# OXFORD VALLEY MALL DAM

PHASE I INSPECTION REPORT  
NATIONAL DAM INSPECTION PROGRAM

Name of Dam: Oxford Valley Mall Dam  
County Located: Bucks County  
State Located: Pennsylvania  
Stream: Queen Anne Creek  
Coordinates: Latitude 40° 11.0'  
Longitude 74° 52.5'  
Date of Inspection: October 25, 1979

FIELD OBSERVATION PLAN  
 OXFORD VALLEY MALL DAM

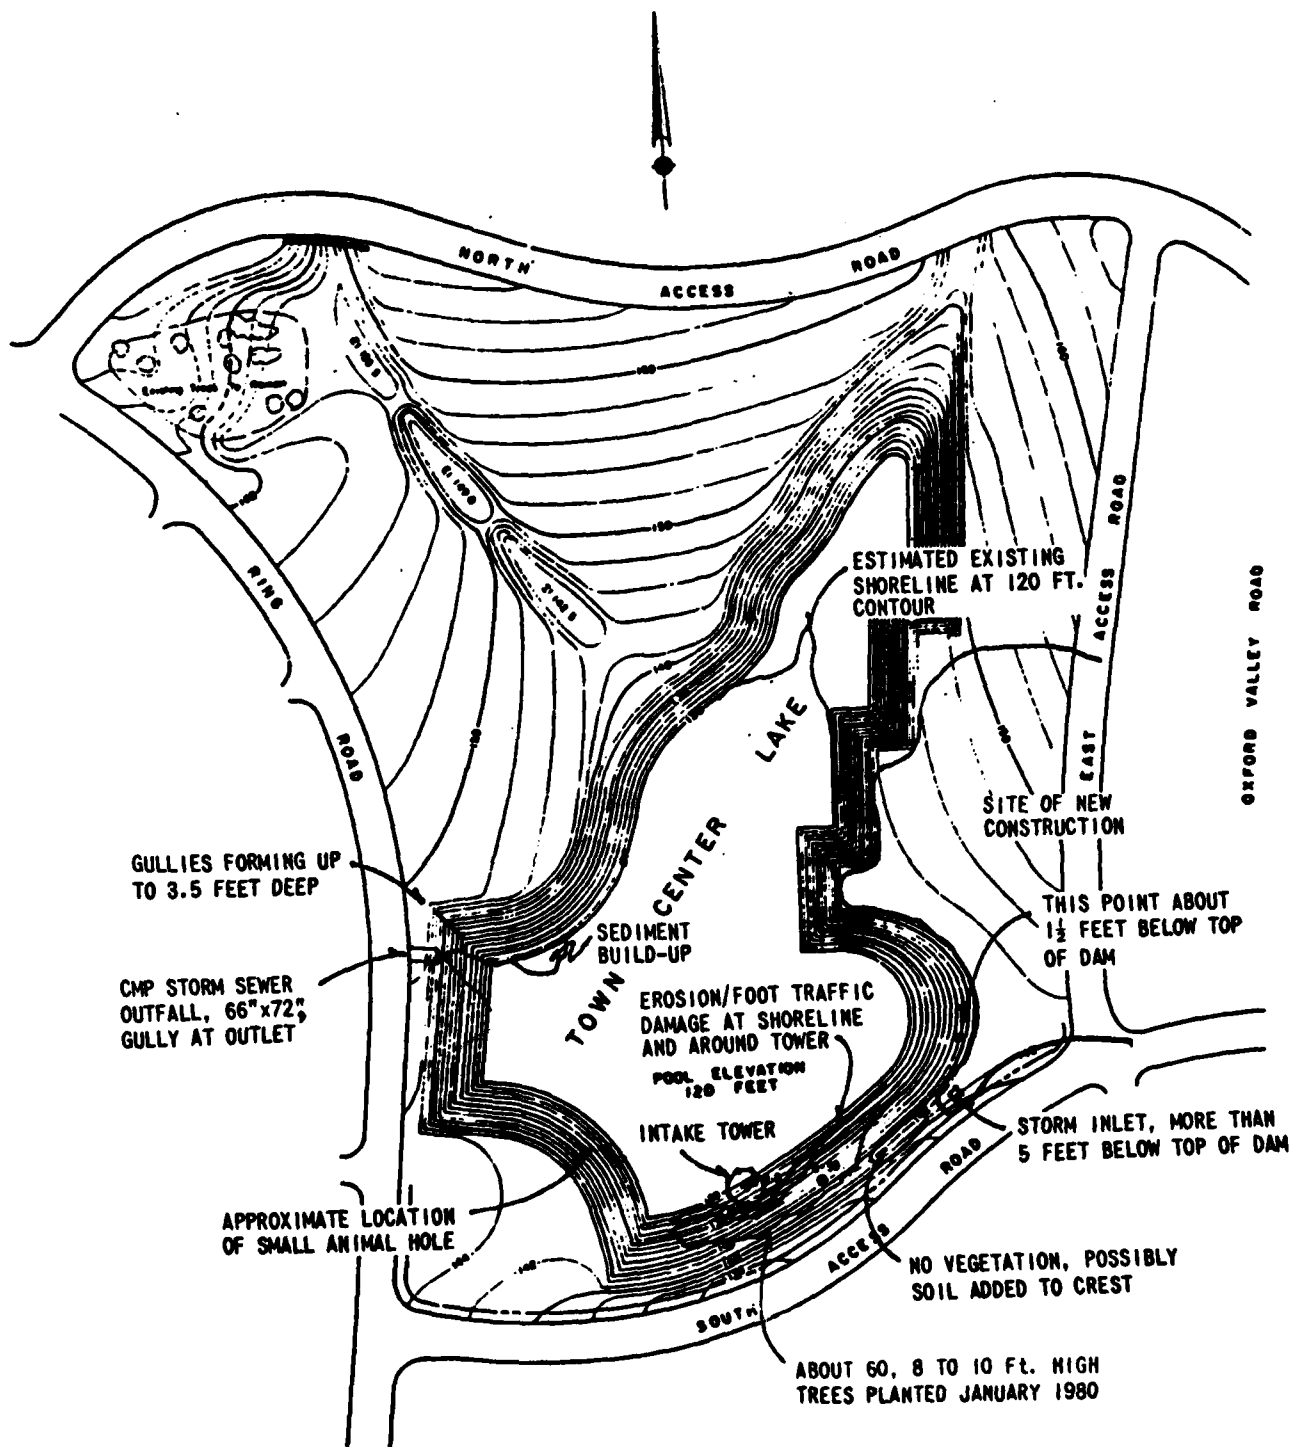
Vertical and horizontal alignment appeared good, but new construction in progress at the left abutment could lower the crest elevation.

January 1980 about sixty 8 to 10 foot high trees were planted. These should be removed and the slope restored to its original condition.
